# Sneak Circuit Analysis of F-4C Flight Control System

DOCUMENT NO. D2-118545-1

MODEL NO. F-4C CONTRACT NO. F33657-74-C-0686

FIGURE 1  
 STABILATOR FEEL TRIM ACTUATOR CIRCUITRY

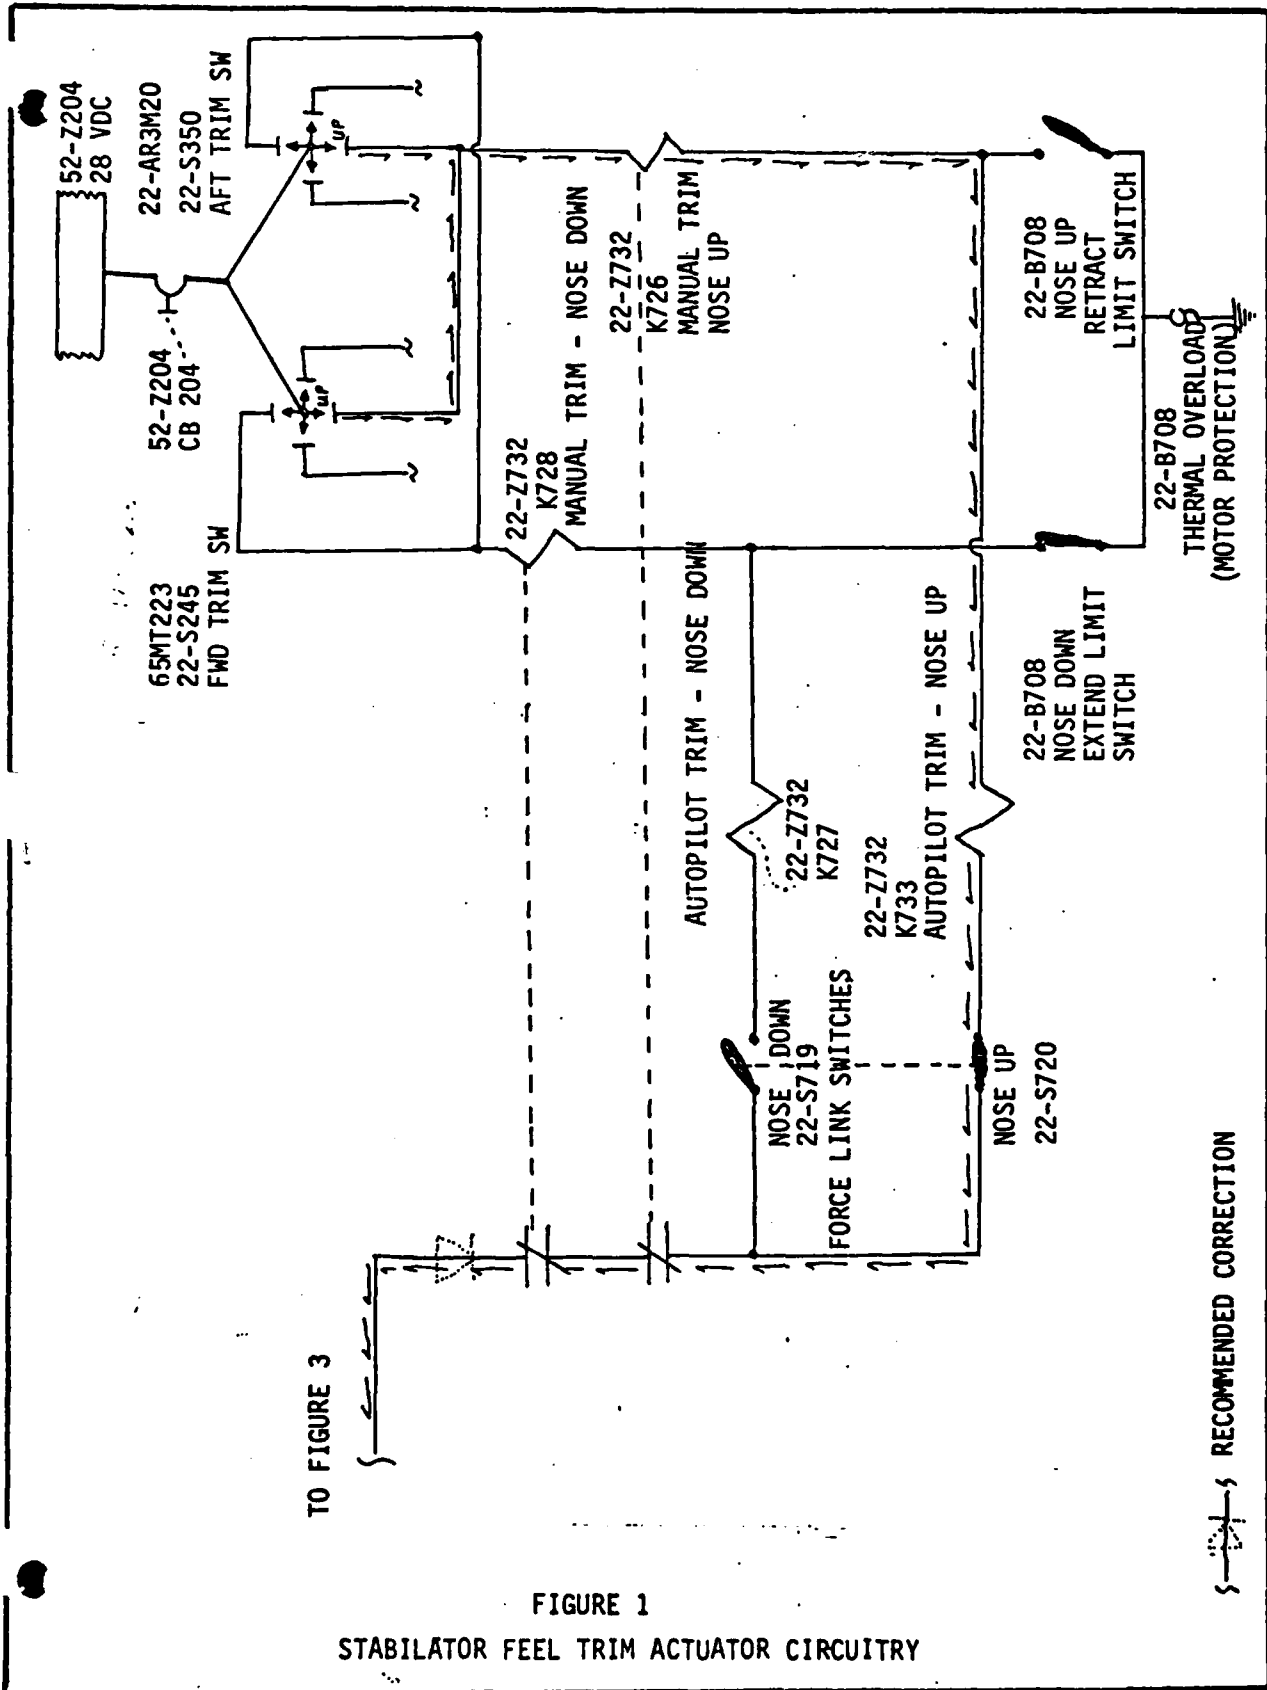
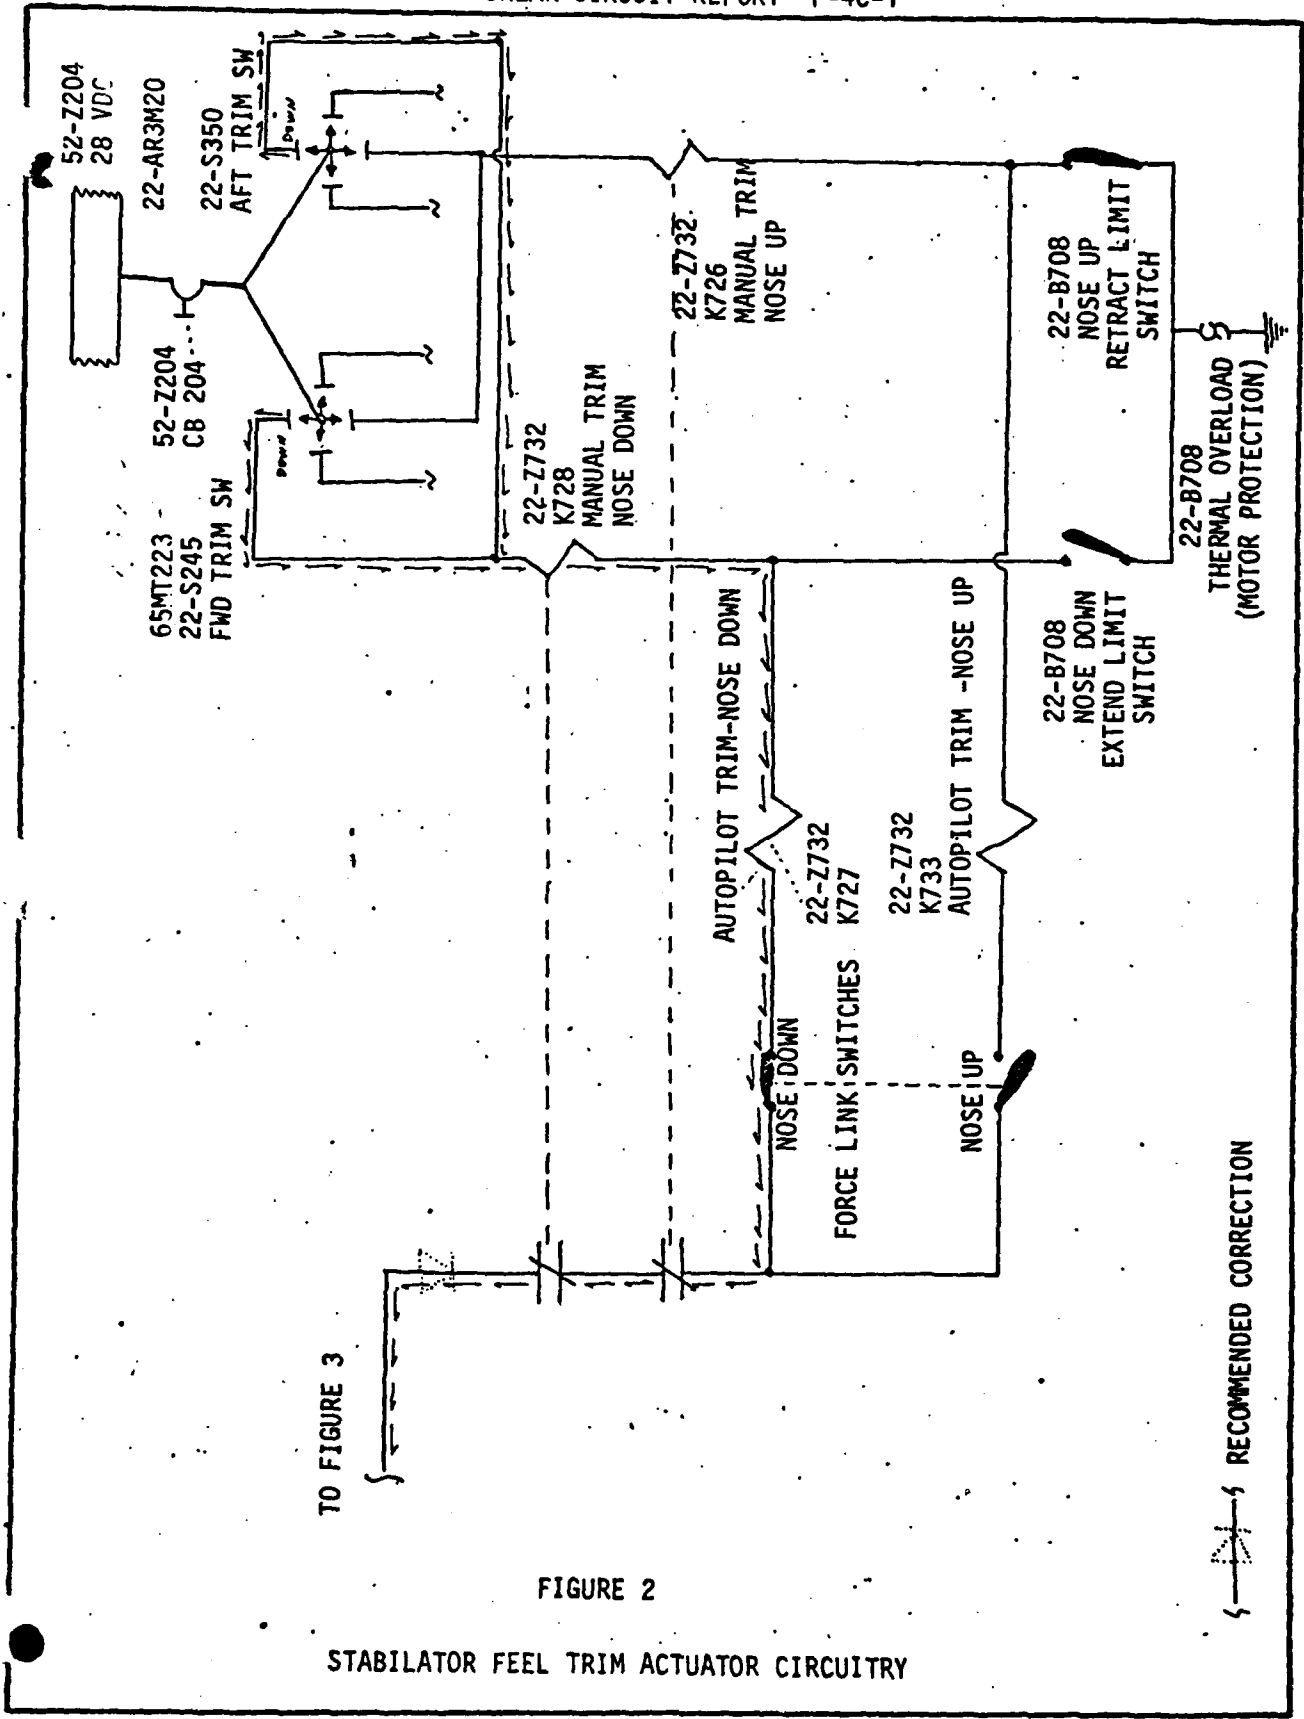
When the Stabilator Feel Trim Actuator Motor reaches its retract limit, the Nose Up Retract Limit Switch in ref. des. 22-B708 opens as shown in figure 1. If the FWD Trim Switch (22-S245) in ref. des. 65-MT223 or the AFT Trim Switch (22-S350) in ref. des. 22-AR3M20 is pushed to the UP position when either control stick is pulled back, the Trim Nose Up Force Link Switch (22-S720) is closed and the sneak path shown in figure 1 is established. Current will flow only when AFCS is disengaged. Current flows through the Manual Trim-Nose Up Relay (K726) in ref. des. 22-Z732 and through the Autopilot Trim Nose Up Relay (K733) in ref. des. 22-Z732. It then flows through the Force Link Switch and the Manual Trim Nose Up (K726) and Nose Down (K728) relay contacts. Current can then flow to ground by a number of paths depending on switch positions and relay contact closures discussed below. It is possible that relay K726 could be energized, causing relay chatter.

As shown in figure 2, a similar sneak path results when the Stabilator Feel Trim Actuator Motor reaches its extend limit and the Nose Down Extend Limit Switch in ref. des. 22-B708 opens. If a trim switch is then pushed to the Down position when either control stick is pushed forward, the Nose Down Force Link Switch (22-S719) is closed, current will flow through the Manual Trim-Nose Down Relay (K728) in ref. des. 22-Z732 and the Autopilot Trim-Nose Down Relay (K727) in ref. des. 22-Z732. Current could then flow to ground by the paths described below:

Add a diode in the location shown in Figures 1 and 2.

FIGURE 3  
 AFCS RELAY SWITCHING

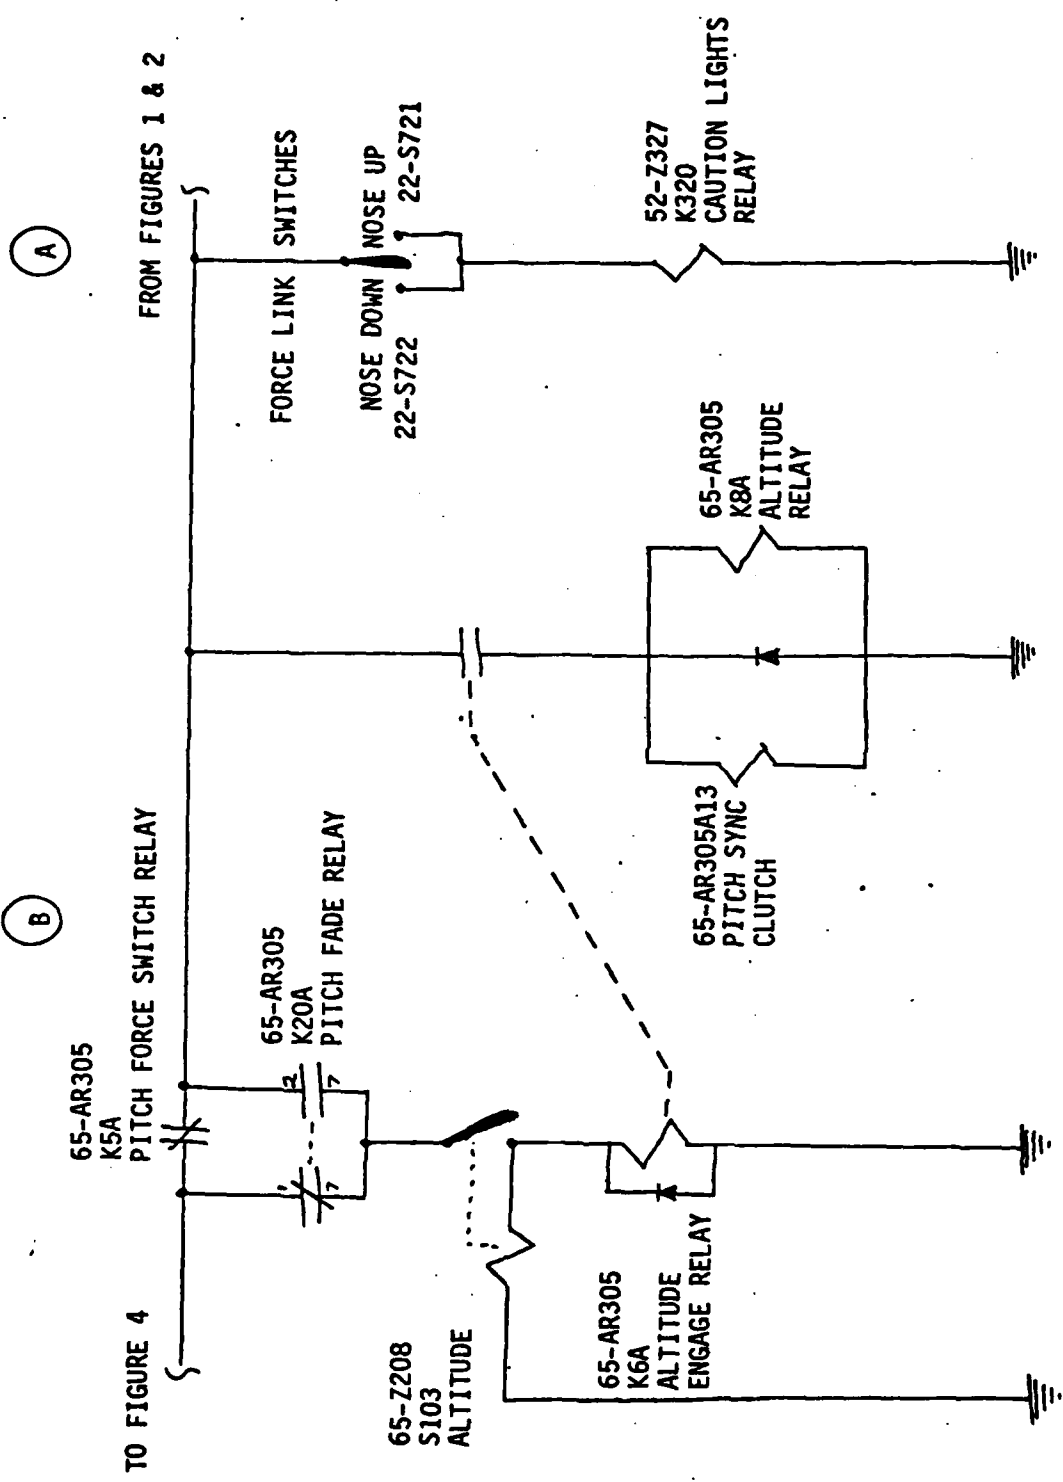
- Path A. As shown in Figure 3, if one of the 5 pound Warning Light Force Link Switches (22-S721 and 22-S722) is closed, power could be inadvertently fed to the Caution Lights Relay (K320) in ref. des. 52-Z327 which will turn on the A/P Pitch Trim Indicator, giving a false indication.

- Path B. If the Pitch Fade Relay (K20A - not shown) in ref. des. 65-AR305 has been energized so that relay contacts 2 and 7 in Figure 3 are closed, or if neither K20A nor the Pitch Force Switch Relay (K5A) in ref. des. 65-AR305 has been energized, a path will be established to the Altitude Switch (S103) in ref. des. 65-Z208. If it is depressed, it will activate its holding coil and the Altitude Engage Relay (K6A) in ref. des. 65-AR305. This will close the K6A relay contacts, allowing current to flow to the Pitch Sync Clutch in ref. des. 65-AR305A13 and to the Altitude Relay (K8A) in ref. des. 65-AR305. This will enable the Altitude Hold Circuitry even though AFCS is disengaged.

FIGURE 4  
AFCS RELAY SWITCHES

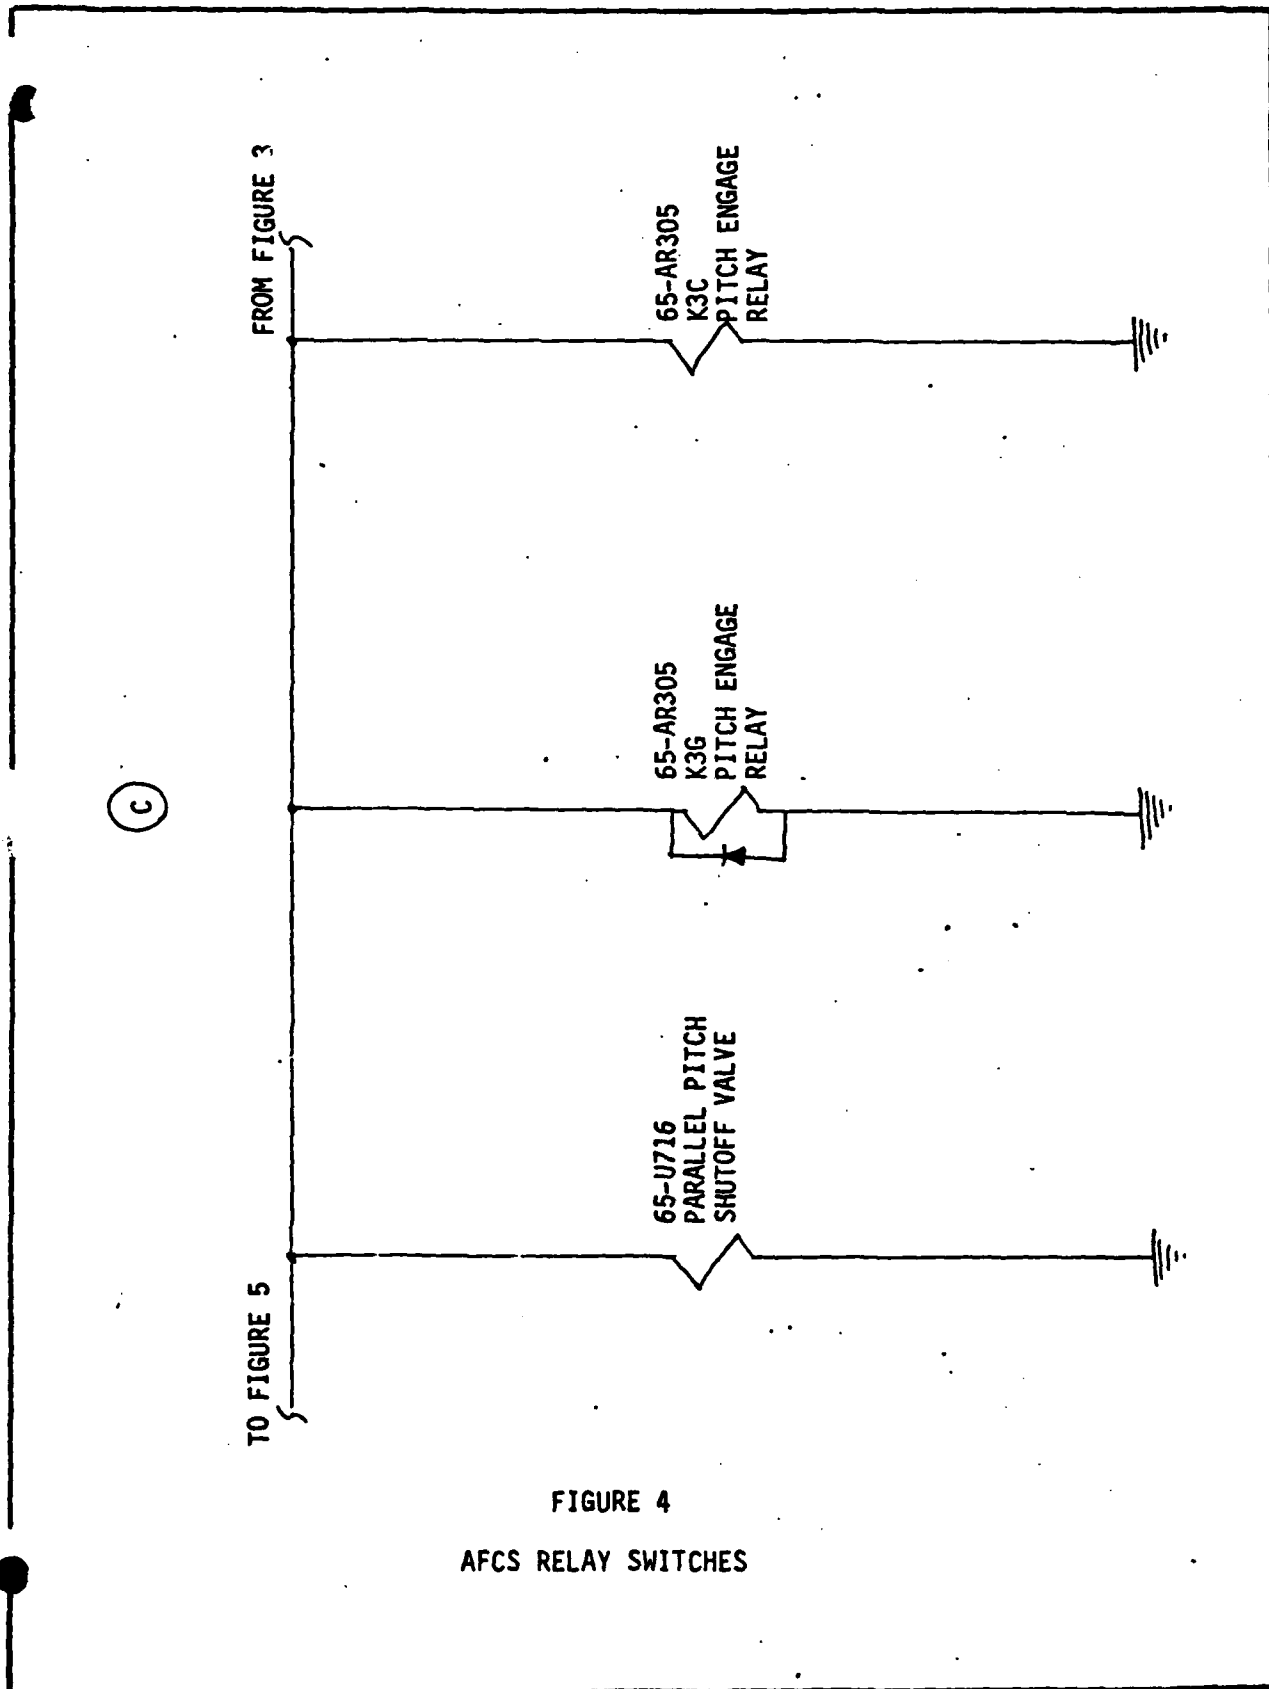
- Path C. As shown in figure 4, power can flow to the Parallel Pitch Shutoff Valve in ref. des. 65-U716 and to the Pitch Engage Relays (K3G and K3C) in ref. des. 65-AR305. This could cause the Pitch Channel of AFCS to be enabled even though AFCS is disengaged.

FIGURE 5  
AFCS RELAY SWITCHING

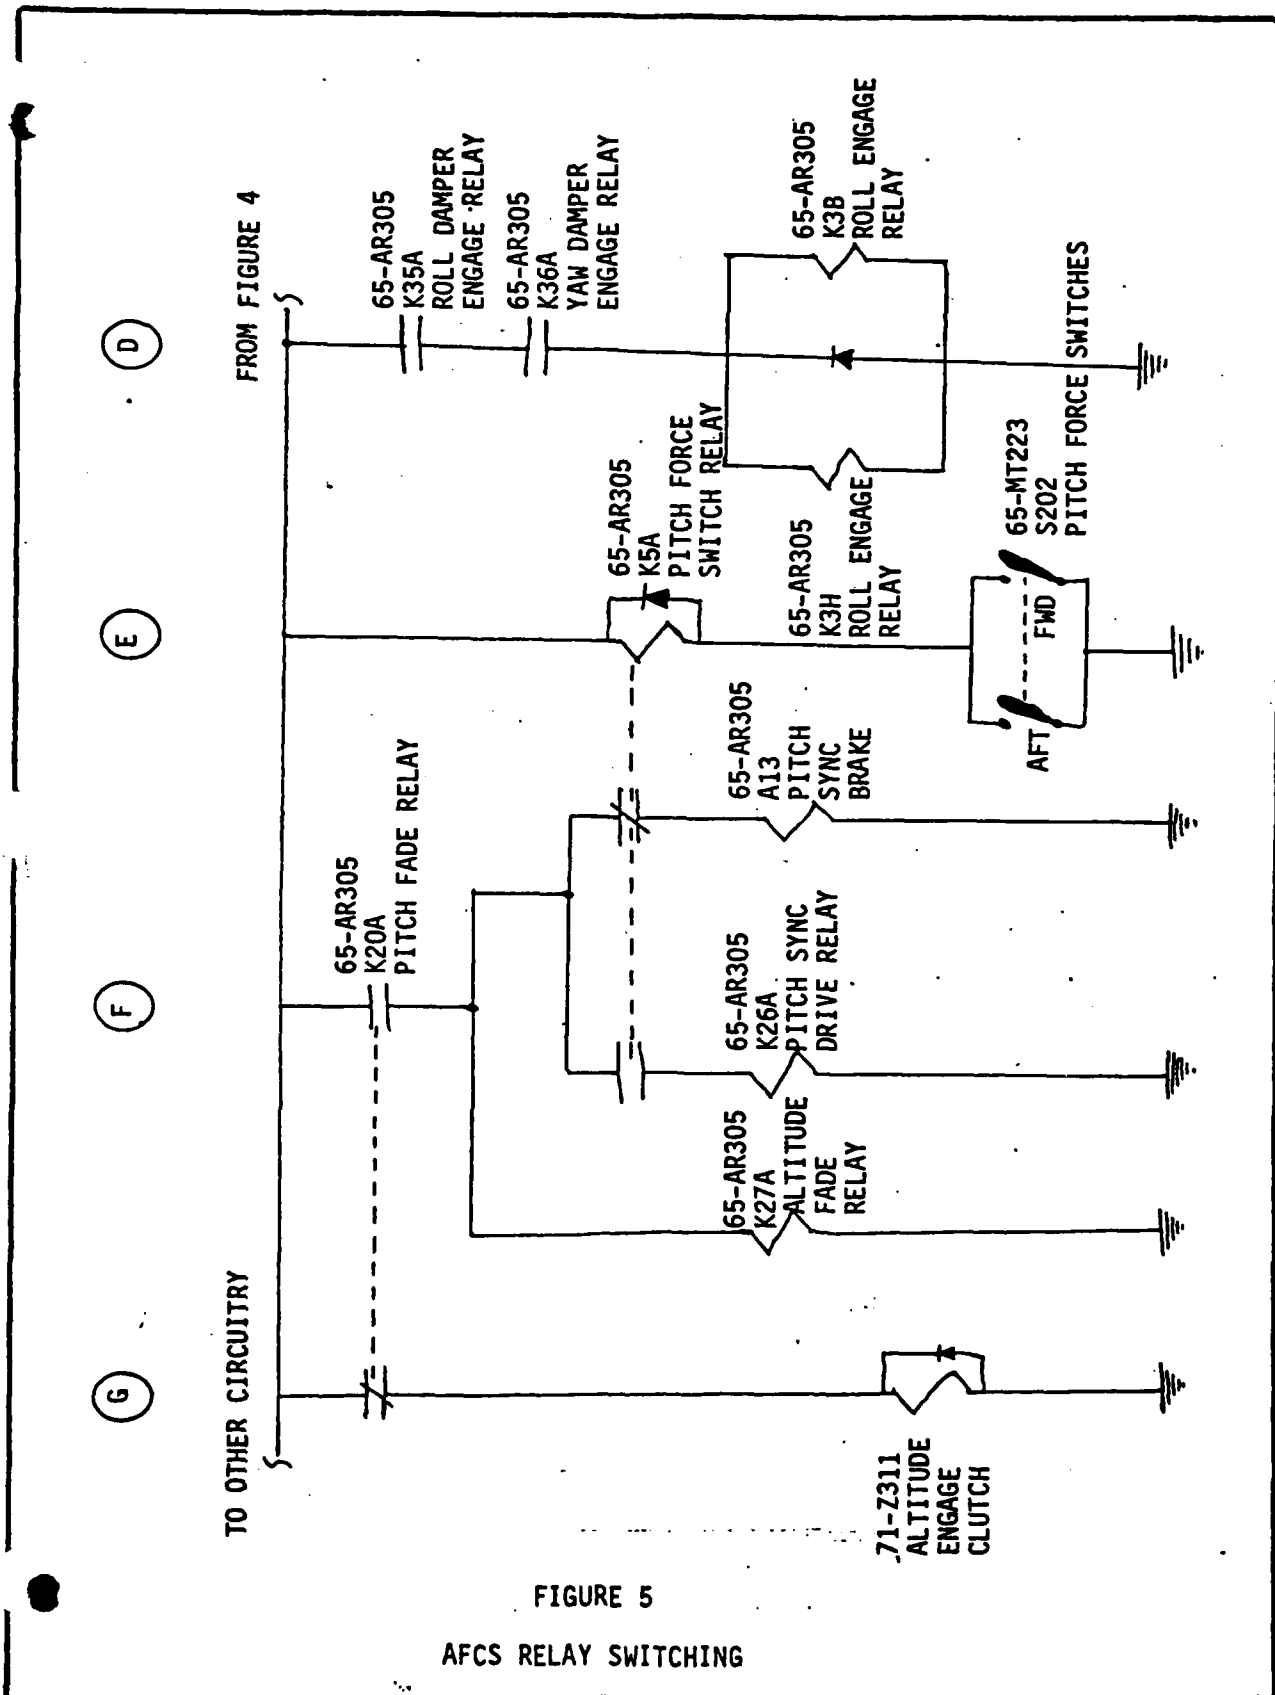
- Path E. As shown in figure 5, if the FWD or AFT Pitch Force Switch (S202) in ref. des. 65-MT223 is thrown, the Pitch Force Relay (K5A) may be energized. If it energizes, it would cause relay chatter since its contacts in figure 3 are between it and the power source.

- Path F. If the Pitch Fade Relay (K20A) in ref. des. 65-AR305 is energized power is fed, as shown in Figure 5, to the Altitude Fade Relay (K27A) in ref. des. 65-AR305 and to the Pitch Sync Brake in ref. des. 65-AR305A13.

- Path G. As shown in figure 5, if the Pitch Fade Relay (K20A) is not energized, power is fed to the Altitude Engage Clutch in ref. des. 71-Z311.
